UNITED STATES PATENT AND TRADEMARK OFFICE

APPLICATION NO.	FILING DATE	FIRST NAMED INVENTOR	ATTORNEY DOCKET NO.	CONFIRMATION NO.
10/721,321	11/26/2003	Yang Hwan No	0465-1090P	8388
2292	7590	06/18/2007	EXAMINER	
BIRCH STEWART KOLASCH & BIRCH			RIGGLEMAN, JASON PAUL	
PO BOX 747			ART UNIT	PAPER NUMBER
FALLS CHURCH, VA 22040-0747			1746	
NOTIFICATION DATE		DELIVERY MODE		
06/18/2007		ELECTRONIC

Office Action Summary	Application No.	Applicant(s)	
	10/721,321	NO ET AL.	
	Examiner	Art Unit	
	Jason P. Riggleman	1746

DETAILED ACTION

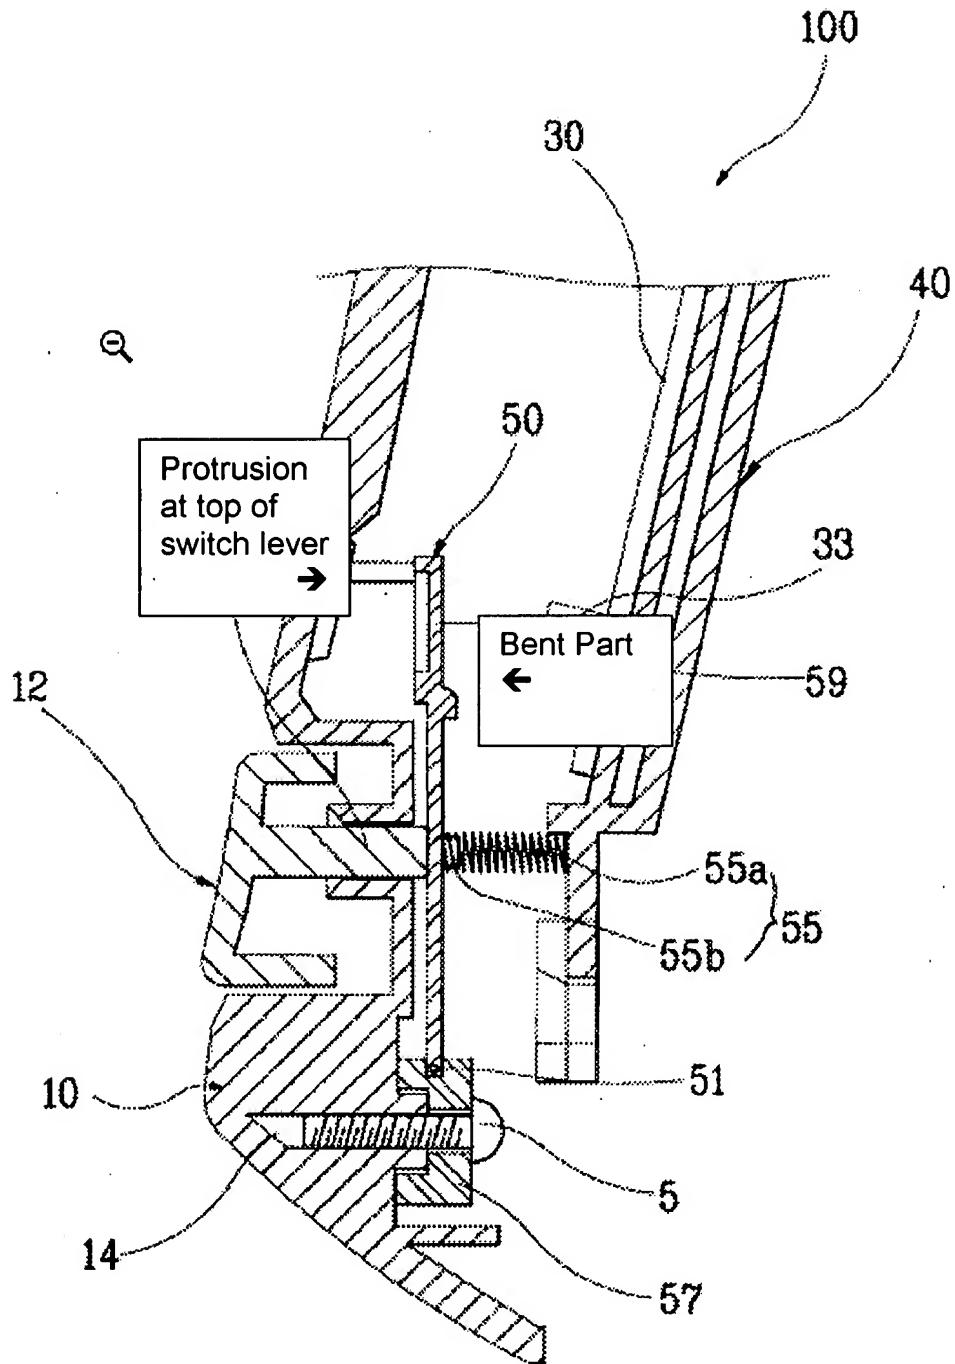
3. Kim teaches a control panel 10 of a washing machine (see English abstract). A display panel has openings where buttons 12 are located. A display substrate 40 in rear of the display panel has at least one switch 33 formed thereon. The switch lever 50 has one end fixed to a backside of the display panel and the other end disposed over the switch, the other end of the switch lever (directly above the switch) directly presses the switch when an external force is applied to the button, Figs. 3a-3b. A lever loading part (rotation fixing part 51) is formed on the backside of the display panel and the switch lever is coupled with the lever loading part. A coupling recess (hole) is formed at the lever loading part and a protrusion (pin) is inserted in the coupling recess formed at the switch lever. An elastic part (elastic recovery element 55) is behind the display panel to provide a restoring force for the switch lever to return to an original state when the external force applied to the button is released. A button protrusion is formed at a

bottom 12a of the button 12 to be brought into contact with the switch lever 50. A bent part is formed at one end of the switch lever 50, Fig. 3b. The button is free of contact with the display substrate when an external force is applied to the button. A protrusion is formed at a top of the switch lever to be brought into contact with the switch lever once the external force is applied to the button (See drawing below).
